# Access Compliance Report

## Public Rights-of-Way

Intersection ID: 3051	Main Street: WHITE_STAG_DR	Cross Street: WHITE_STAG_DR	Location: NW
ADA ID: B56163E04FDD	Ramp Type: Perp	Initial Pass/Fail: Fail	Overall Compliance: No
Severity Score: 31.25			
Codes/Mitigation Info/Possible Solution		Field Measurements/Component Compliance

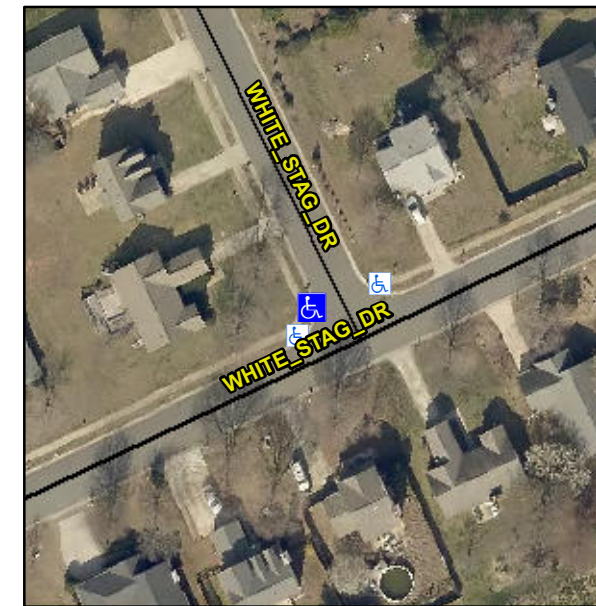
**Remove & Replace Entire Ramp.**

**R304.5.1, R304.2.2, R304.5.3**

Compliance	Description	Data	Compliance	Description	Data
N/A	Ramp Length (in)	47.0	No	Ramp Slope (%)	10.4
No	Ramp Width (in)	32.0	No	Ramp XSlope (%)	3.1
N/A	Flare Type LT	N/A	N/A	Flare Type RT	N/A
N/A	Flare Slope LT (%)	N/A	N/A	Flare Slope RT (%)	N/A
N/A	Flare Traversable LT?	N/A	N/A	Flare Traversable RT?	N/A
N/A	Landing Length (in)	N/A	N/A	DWS Provided?	N/A
N/A	Landing Width (in)	N/A	N/A	DWS Contrast?	N/A
N/A	Landing Slope (%)	N/A	N/A	DWS Length (in)	N/A
N/A	Landing X Slope (%)	N/A	N/A	DWS Full Width?	N/A
N/A	Landing Curb? (Y/N)	N/A	N/A	DWS Offset (in)	N/A
N/A	Shared Landing?	N/A			
N/A	Gutter Ponding?	N/A	N/A	Gutter Slope (%)	N/A
N/A	Gutter Lip Ht (in)	N/A	N/A	Gutter X Slope (%)	N/A
N/A	Painted X Walk1?	No	N/A	Painted X Walk2?	N/A
	X Walk 1 Direction	To E		X Walk 2 Direction	N/A
N/A	X Walk 1 Width (in)	N/A	N/A	X Walk 2 Width (in)	N/A
	X Walk 1 Slope (%)	4.2		X Walk 2 Slope (%)	N/A
	X Walk 1 X Slope (%)	2.0		X Walk 2 X Slope (%)	N/A
